HIGH-LEVEL WASTE **TANK CLOSURE** Final Environmental Impact Statement

DEPARTMENT OF ENERGY
SAVANNAH RIVER
OPERATIONS OFFICE
AIKEN, SOUTH CAROLINA
DOE/EIS-0303

May 2002

Figure 3.1-3. Savannah River Site, showing seismic fault lines and locations of onsite earthquakes and their years of occurrence.

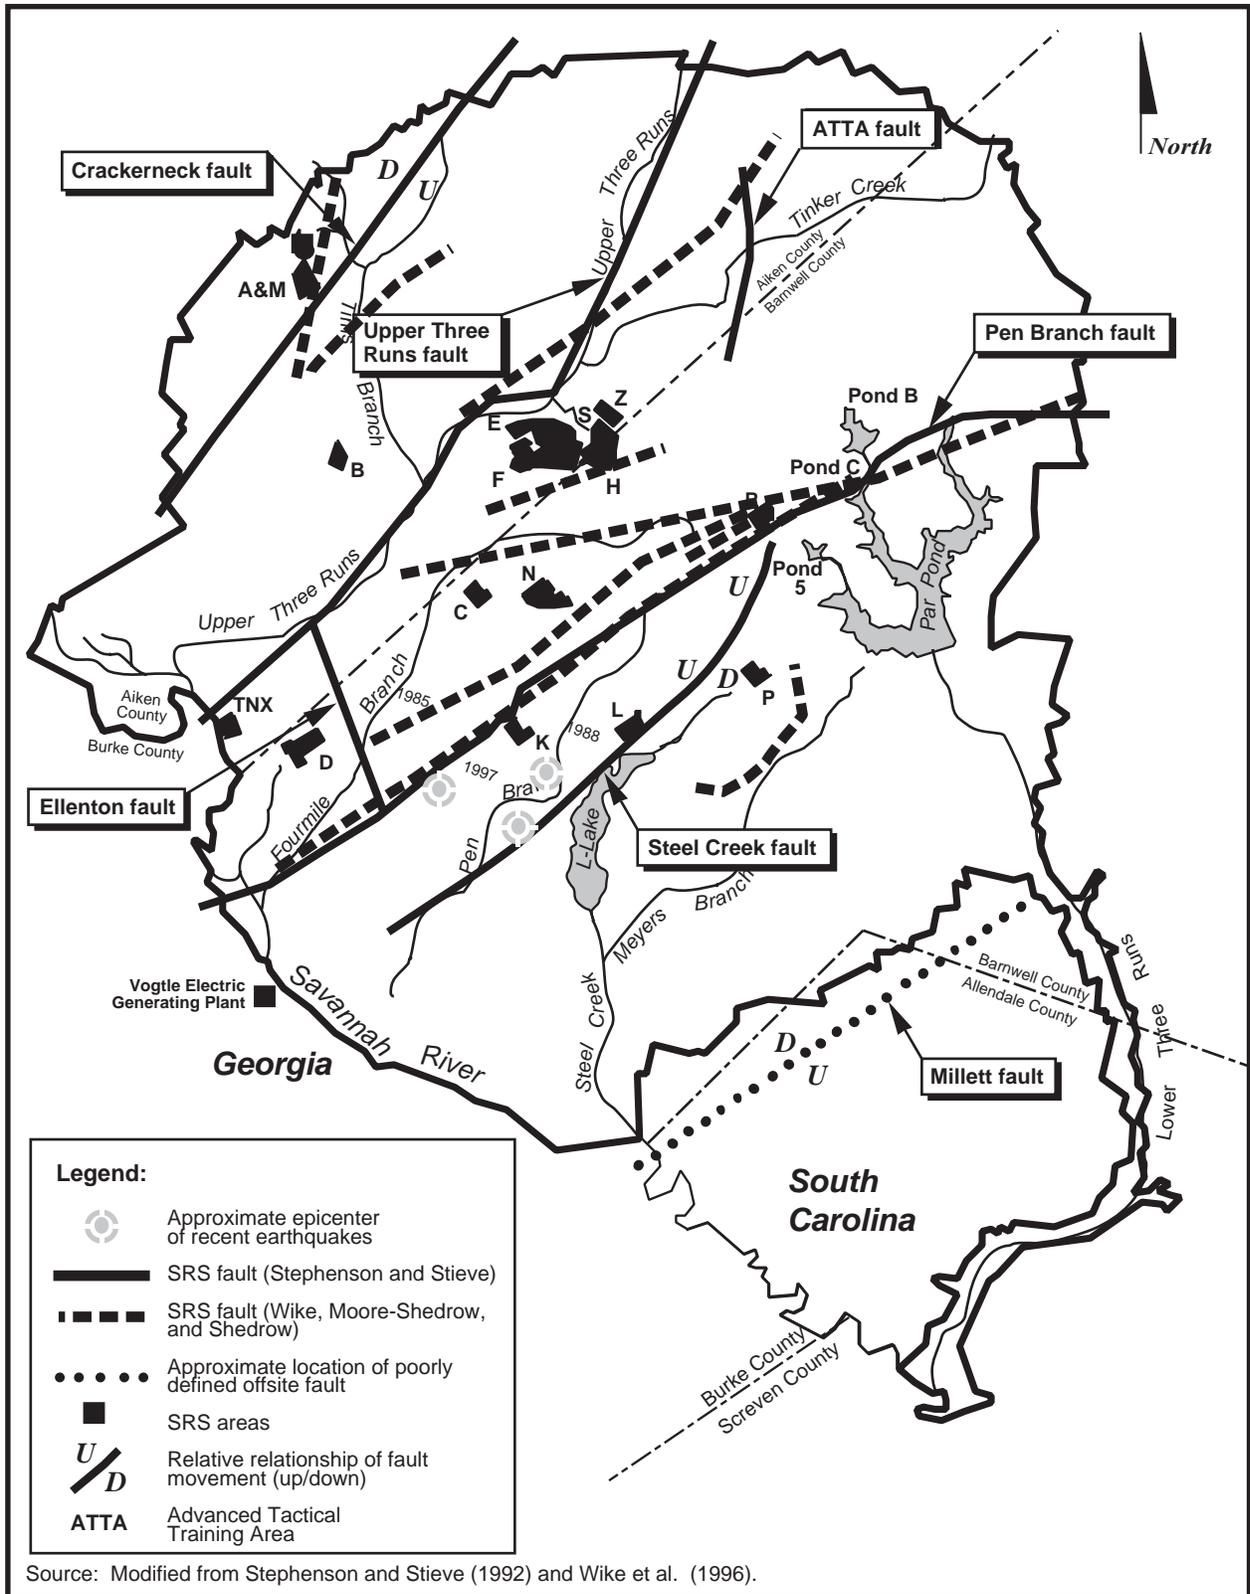
Section 3.1.3 (Seismicity) and Figure 3.1.1 (map of seismic fault lines) of EIS-0303D indicate the presence of a previously unknown fault (H-Fault ... for lack of another name) that passes through the southeastern corner of H-Area (Wike et al. 1996, WSRC-TR-96-0279 Rev. 1, p4-14). Previous hydro-geological studies of Sr-90 transport (Carlton et al., WSRC-RP-92-984) in this same area of SRS (Four-Mile Creek side of the water table divide) report that "much of the groundwater flow in this area of the plant appears to occur in narrow, high permeability channels in the sediments." It was suggested that the majority of the flow of underground contaminants entering the water table in this portion of H-Area follow these channels to outcrop into Four-Mile Creek. A similar study of Cs-137 transport (Carlton et al., WSRC-RP-92-250, p4-11) suggests "facilitated transport is taking place in this locality."

Figure 3.2-5. Maximum reported groundwater contamination in excess of regulatory/DOE limits at Savannah River Site.

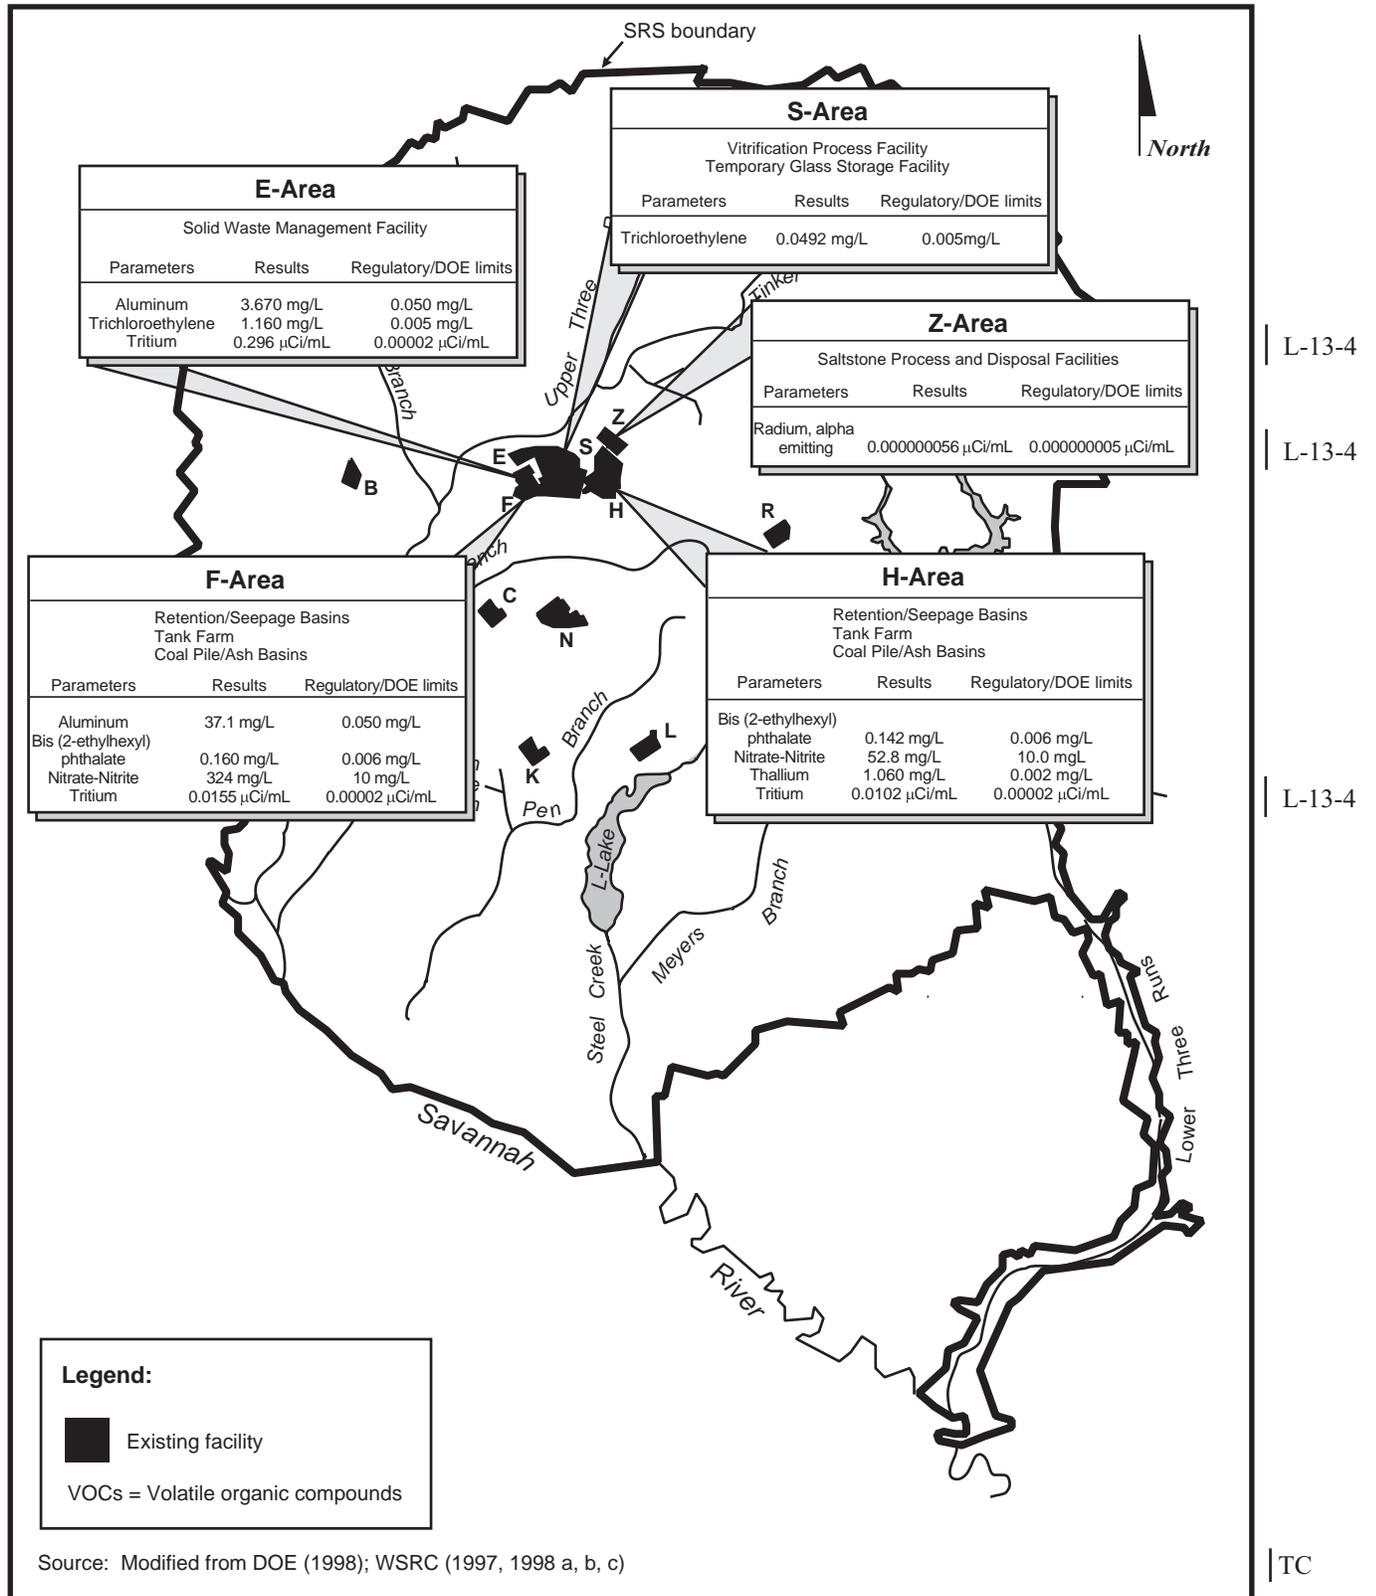
Tables 3.2-3, 3.2-4, and 3.2-5 report the maximum groundwater contaminant concentrations for parameters in excess of the regulatory limit for E-Area, F-Area, and H-Area, respectively. Likewise, Figure 3.2-5 provides a map of these areas with some of the same results listed. However, there may be a typo or else some confusion over units for tritium. The tables provide tritium concentrations in uCi/ml (micro), whereas the map reports tritium concentrations in mCi/ml (milli). For example, Table 3.2-3 indicates that the maximum tritium concentration in E-Area was 2.96×10^{-1} uCi/ml, whereas Figure 3.2-5 indicates that the maximum concentration was 0.296 mCi/ml, which would actually be 2.96×10^{-2} uCi/ml or 1000 times higher than reported in the table. Presumably the intent was to report in uCi/ml.

Response to comment L-13-4: The units shown on Figure 3.2-5 for tritium were incorrect and have been revised (all constituents, in addition to tritium, have been checked and revised as needed).

Figure 4.2.2-1. Predicted drinking water dose over time at the H-Area seepline north of the groundwater divide in the Barnwell-McBean and Water Table Aquifers.

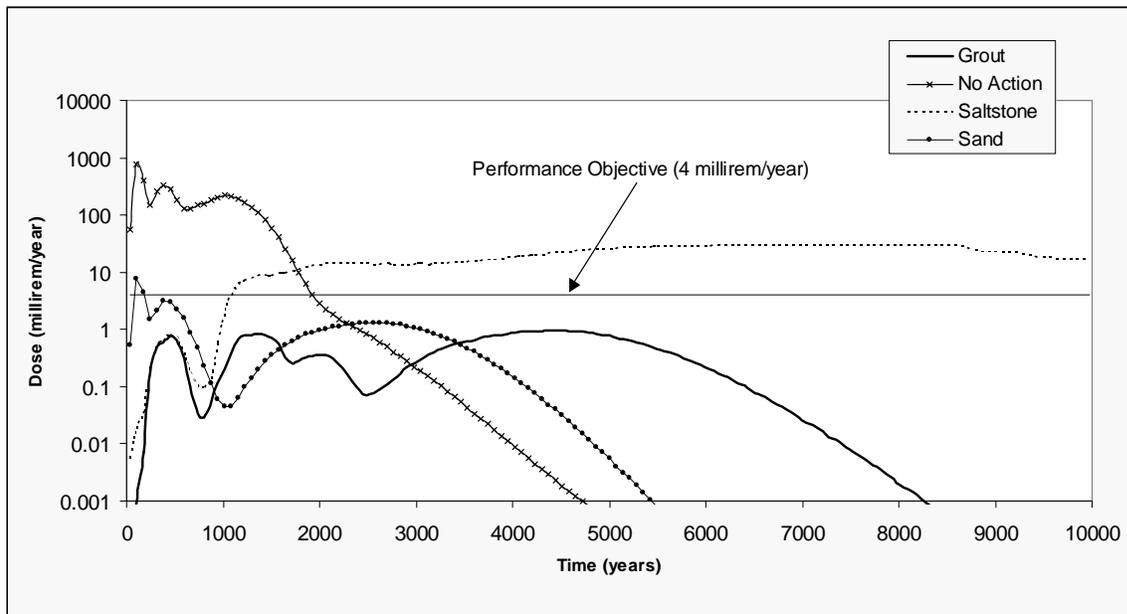
| 8. Figure S-7: To assist the reader in being able to quickly see when the closure criteria is estimated to become exceeded and by how much, please draw a horizontal line in the figure at 4 mrem to represent the closure criteria. | L-2-13 |

6. Table 4.2.2-6 (page 4-37) doesn't seem to include iron from the steel of the tanks. What are the impacts of this iron? | L-7-49
7. Text associated with Figure 4.2.2-1, should describe when the plutonium is expected to arrive at the seep line and what impact it may have on dose rate. I expect it is beyond the 10,000 year analysis period but still should be given in the EIS. | L-7-50

Response to comment L-2-13: Both figures S-7 and 4.2.2-1 have been modified accordingly.

EC | **Figure A-5.** Typical layers of the Fill with Grout Option.

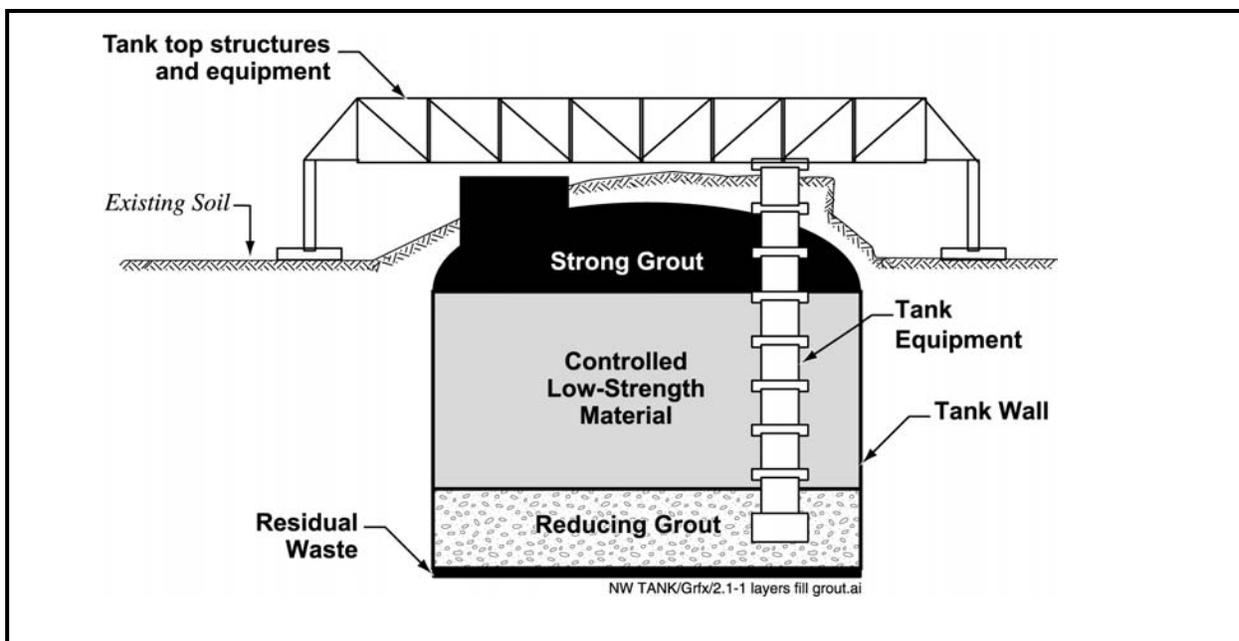
| 1. Page D-5, Figure A-5: The possibility of reusing HLW tanks formerly considered to be retired should be noted. | L-2-15 |
| 2. Figure A-5: The illustration of the tanks that have already been closed (Numbers 20 and 17) is not clear from the figure. Maybe drawing a line through them or separating them from the pack would be clearer. | L-2-16 |

Response to comment L-2-16: Figure E-4 (which was Figure A-5 in the Draft EIS) has been revised to show an “X” through Tanks 17 and 20.

Figure A-6. Area closure example.

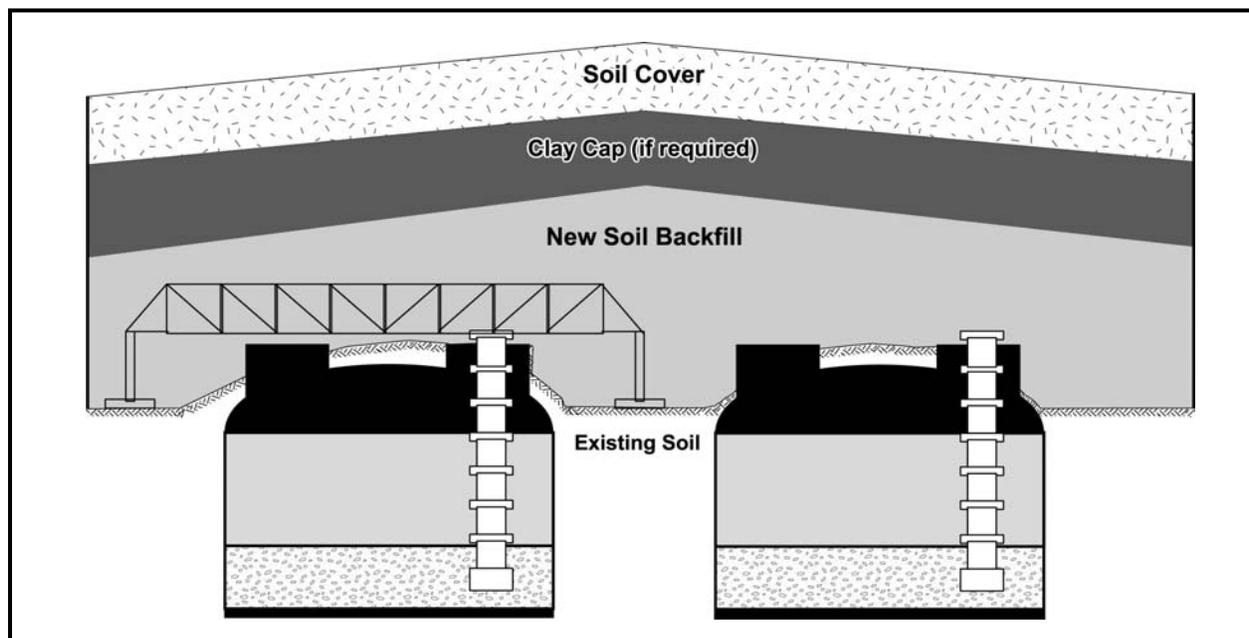
7. Page A-21: While helpful, Figure A-7 seems unclear. Describe the different elements inside of the tanks (viz., currently, the tanks are divided into four unnamed sections; contrast this figure with the clearer Figure 2.1-1). | L-2-21

Response to comment L-2-21: Figure A-6 is provided to present an environmental restoration concept with backfill material and a RCRA/CERCLA type cap shown over the closed tanks. See Figure A-5, Section A.4.4 (which is the same base figure as Figure 2.1-1) for more detail.

Figure C-2. Potential exposure pathways for human receptors.

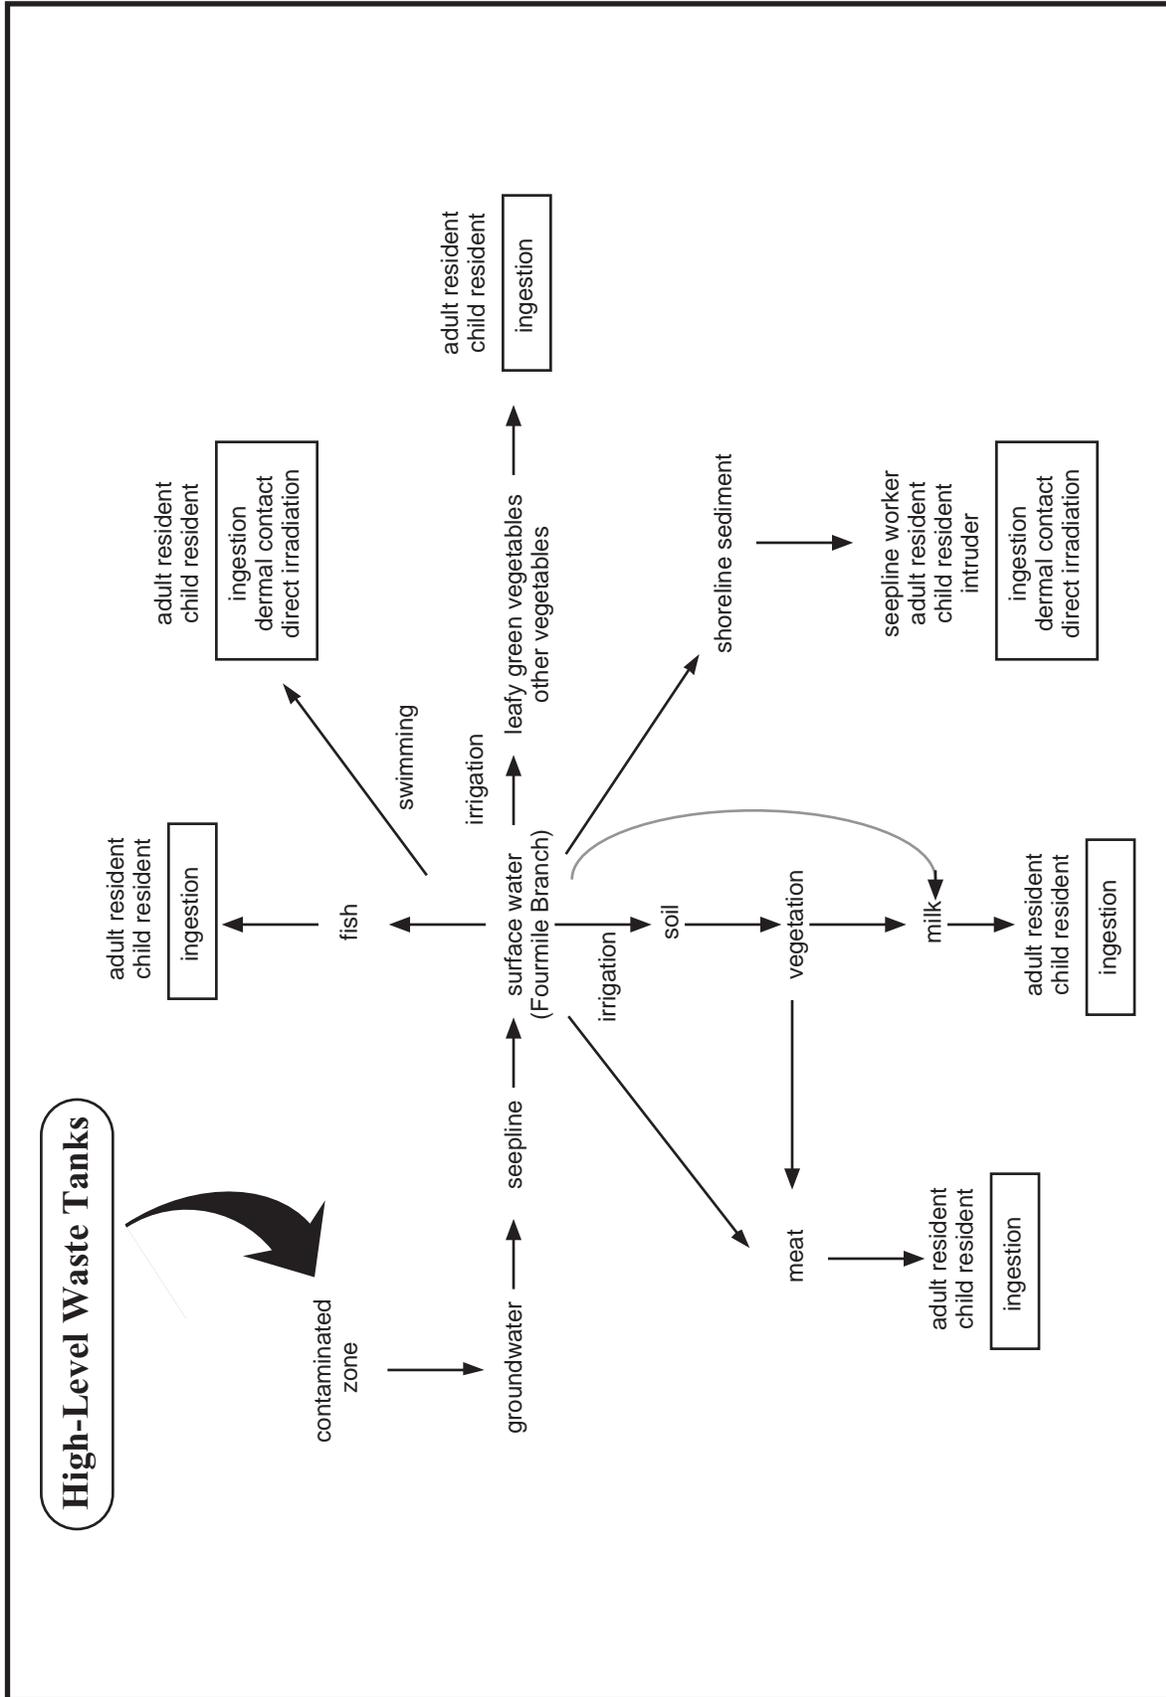
23. Page C-10, Figure C-2, Terrestrial Wildlife Column: When eating, the animals selected could also ingest sediment as well as soils. As a result, clarification is needed on page C-11, Column 2, last section regarding exposure routes. | L-4-26
